Access Compliance Report Public Rights-of-Way (Curb Ramps)

Main Street: CELESTINE_CIR Cross Street: MERRIWEATHER_PL Location: NE

ADA ID: RPAT211029133839 Ramp Type: Type 4 - Parallel Initial Pass/Fail: Pass Overall Compliance: No Severity Score: 20

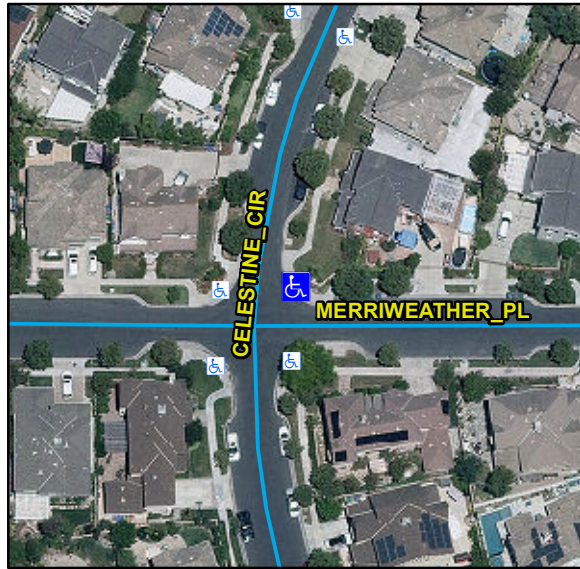
Compliance	Description	Data	Compliance	Description	Data
N/A	Ramp Length LT (in)	65	N/A	Ramp Length RT (in)	90
Yes	Ramp Width LT (in)	54	Yes	Ramp Width RT (in)	54
Yes	Ramp Run Slope LT (%)	5.3	Yes	Ramp Run Slope RT (%)	6.2
Yes	Ramp Cross Slope LT (%)	0.9	Yes	Ramp Cross Slope RT (%)	1.2
N/A	Landing Present	Yes	No	DWS Provided	No
N/A	Landing Length (in)	53	N/A	DWS Contrast	N/A
No	Landing Width (in)	42	N/A	DWS Length (in)	N/A
Yes	Landing Run Slope (%)	0.9	N/A	DWS Full Width	N/A
No	Landing Cross Slope (%)	2.5		DWS Offset Type	N/A
N/A	Landing Movement Obstructed?	No	N/A	DWS Offset Left (in)	N/A
	Landing Movement Type	Curb	N/A	DWS Offset Right (in)	N/A
N/A	Landing Shared	No			
N/A	Clear Space	Yes			
N/A	Clear Space To Crosswalk (in)	48			
N/A	Marked Crosswalk 1	No	N/A	Marked Crosswalk 2	No
	Crossing 1 Direction	W		Crossing 2 Direction	S
	Marked Crosswalk 1 Width (in)	N/A		Marked Crosswalk 2 Width (in)	N/A
N/A	Ramp Inside Crosswalk 1	N/A	N/A	Ramp Inside Crosswalk 2	N/A

Crossing 1 Slope (%)	0.9		Crossing 2 Slope (%)	3.5
	Crossing 1 Cross Slope (%)	1.4		Crossing 2 Cross Slope (%)	1.3
Yes	Gutter Ponding	No	No	Curb Slope	10.1
Yes	Gutter Lip Height (in)	0		Road Run Slope (%)	1.3
No	Gutter Run Slope (%)	7.4		Road Cross Slope (%)	3.3
Yes	Gutter Cross Slope (%)	2	No	Perpendicular Joint Present	No
Yes	Overall Surface Condition	Acceptable			
	Cross Gutter Present?	No		Spandrel Present?	No
	Replace Cross Gutter?	N/A		Replace Spandrel?	N/A

Remove & Replace Curb Ramp With Two New Directional Ramps or Equivalent. Remove & Replace Gutter.
